# Essential Clothing Ltd. (Extension)

23 January 2023

# Observations

**Retrofitting sections**

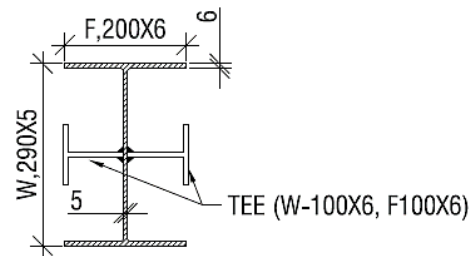
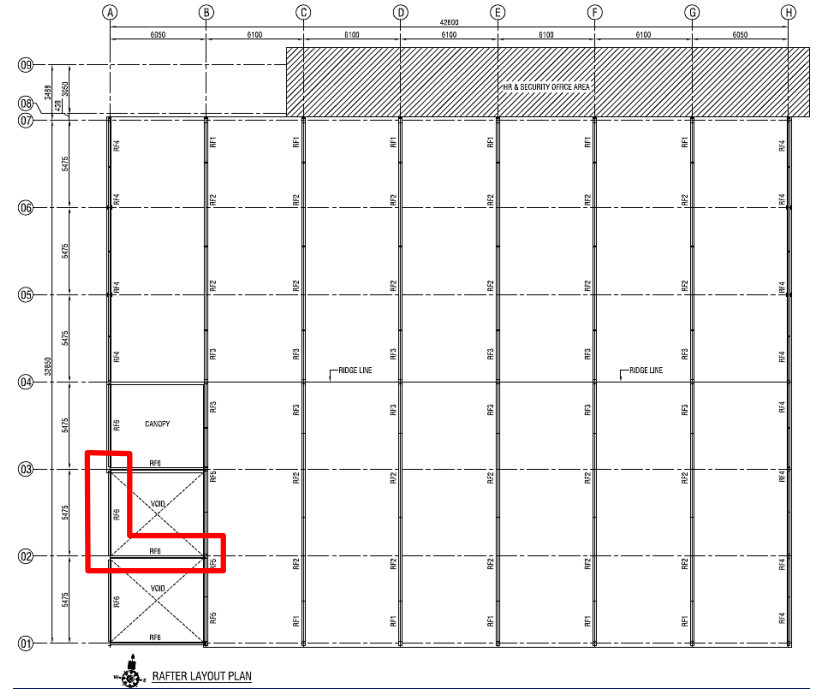
The factory conducted retrofitting with some irregular sections which are modeled with equivalent sections in the analysis software. During inspection Engineering Assessment (EA) report was available onsite. The factory is required to submit the EA report to the RSC for detail review.

| Item No. | Observation                                                               | Recommended Action Plan                                                                                                                                                                         | Recommended Timeline |
|----------|---------------------------------------------------------------------------|-------------------------------------------------------------------------------------------------------------------------------------------------------------------------------------------------|----------------------|
| 01       | Retrofitting design requires detail review (Building-4).                  | <ul style="list-style-type: none"> <li>The factory is required to submit the Engineering Assessment (EA) to the RSC for detail review.</li> </ul>                                               | (6-weeks)            |

Appearance of corrosion in steel members

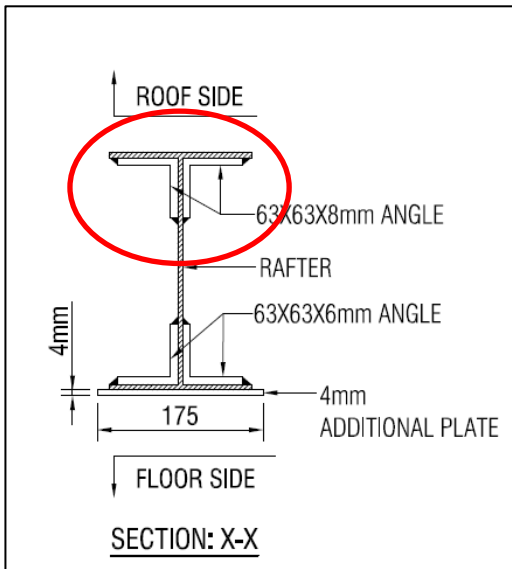
The factory is required to remove the corrosion and apply suitable corrosion resistance coating to the steel members.

| Item No. | Observation                                                               | Recommended Action Plan                                                                                                                                                                         | Recommended Timeline |
|----------|---------------------------------------------------------------------------|-------------------------------------------------------------------------------------------------------------------------------------------------------------------------------------------------|----------------------|
| 04       | Corrosion in steel members (Building-4).                                  | The factory is required to remove the corrosion and apply suitable corrosion resistance coating to the steel members.                                                                           | (6-weeks)            |

Retrofitting Rafter

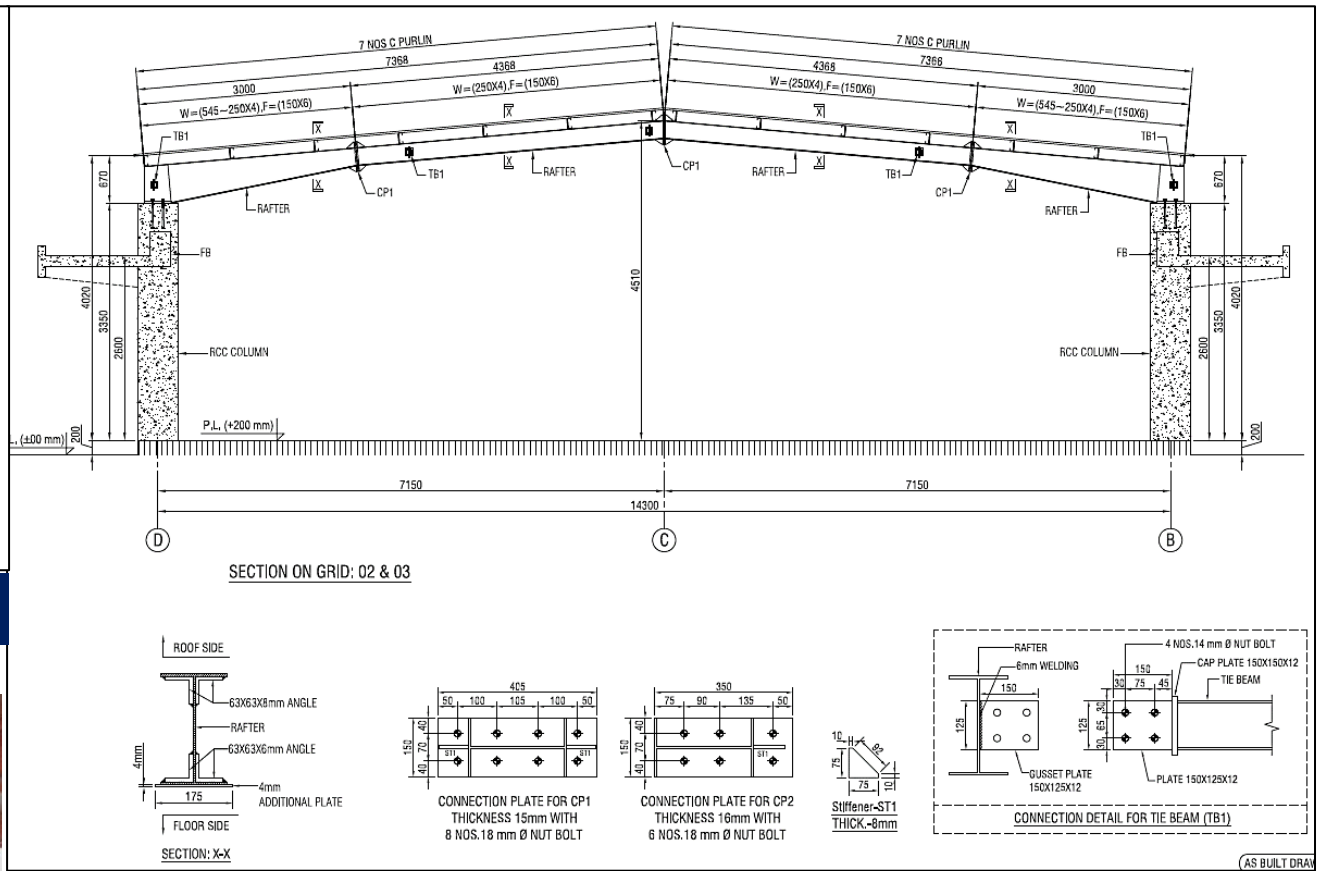
As per retrofitting scheme, additional angle section was required to be added both up & down sides of the steel rafter, but angle section added only to the downside rafter. The building engineer is required to check the adequacy of the current steel rafter and update the EA documents accordingly.

| Item No. | Observation                                                               | Recommended Action Plan                                                                                                                                                                         | Recommended Timeline |
|----------|---------------------------------------------------------------------------|-------------------------------------------------------------------------------------------------------------------------------------------------------------------------------------------------|----------------------|
| 05       | Mismatch between retrofitting drawing and onsite conditions (Building-5). | The building engineer is required to prepare accurate retrofitting drawings, check the design and submit the design documents (EA & retrofitting drawings) report to the RSC for detail review. | (6-weeks)            |
